From: Howard Carter <hc@thinkingspace.co.uk> on behalf of Howard Carter
Sent: 06 July 2020 18:28
To: Marie O'Keeffe
Subject: Re: 21 River Close - awdm/0675/20

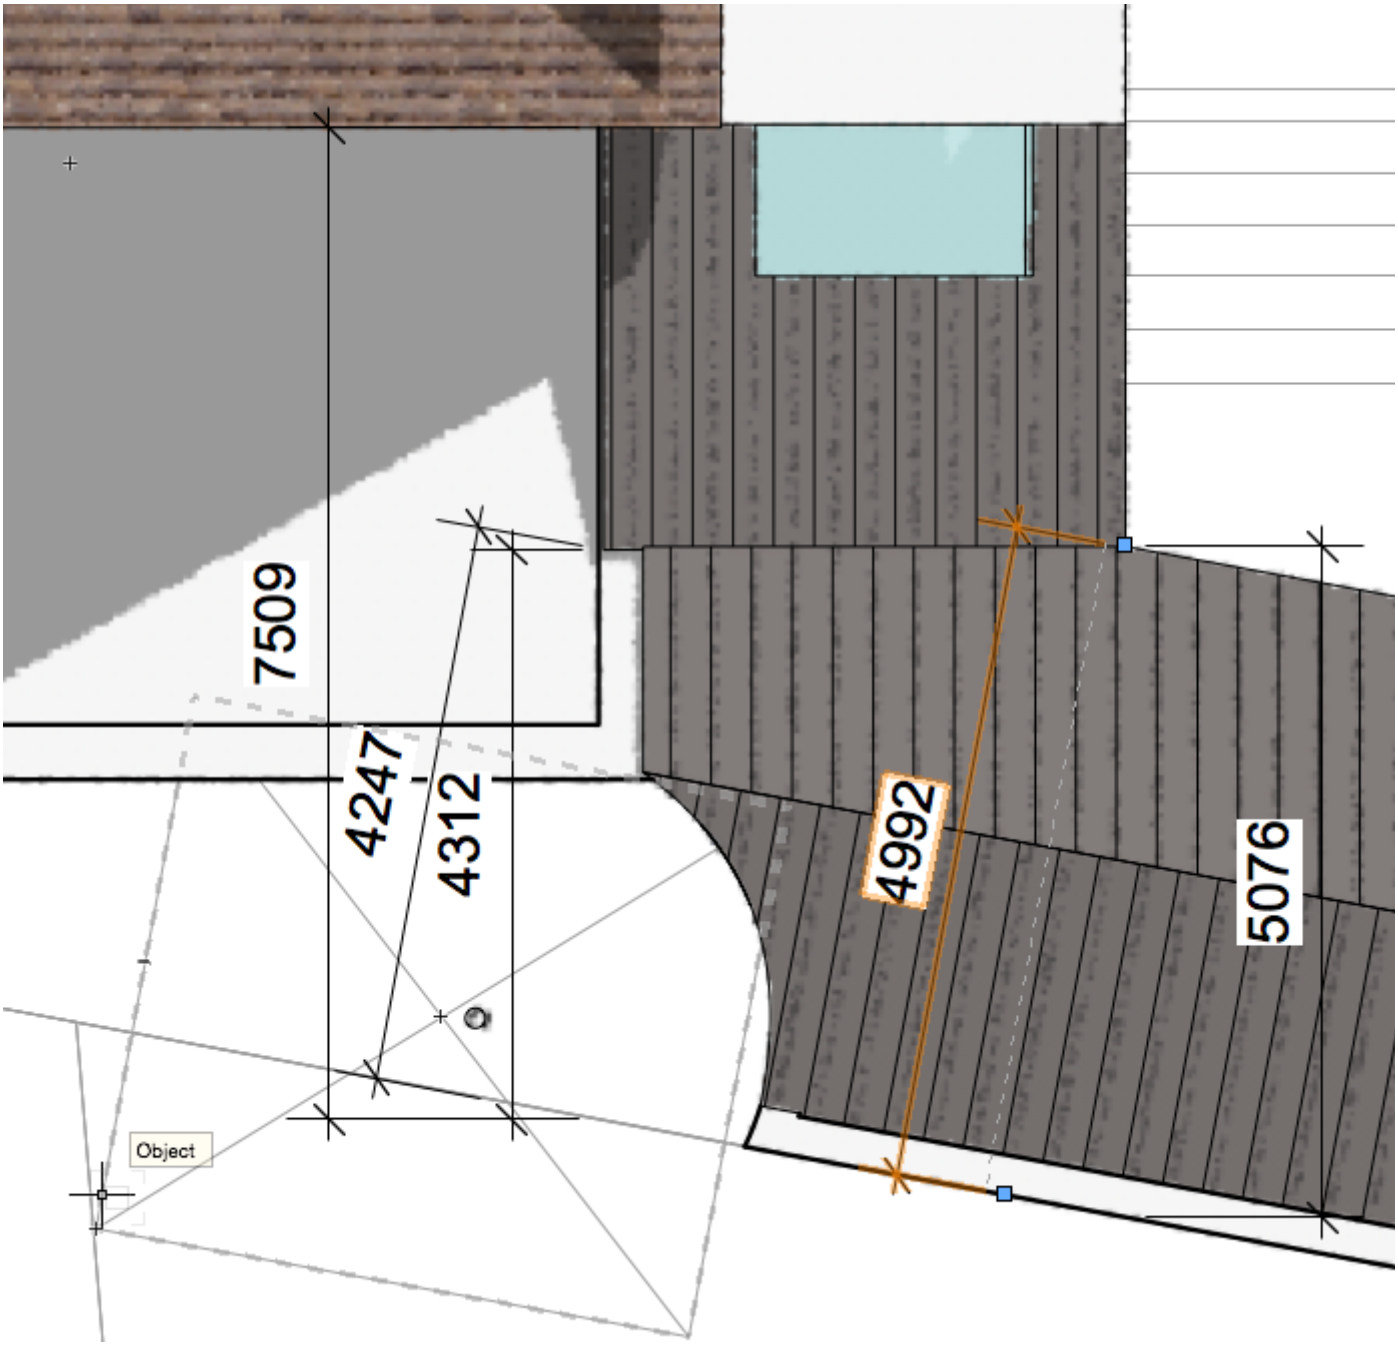
> I measure that the roof slopes away from this boundary to a maximum height of 3 metres over a distance of 2.7 metres from this boundary. Is that correct?

> Is the maximum height of the link addition 3.9 metres from ground level?

> Does the link commence 5 metres off the sahed boundary?

Yes, that is correct.

Yes

See sketch attached with dimensions

max height of link 3.85m
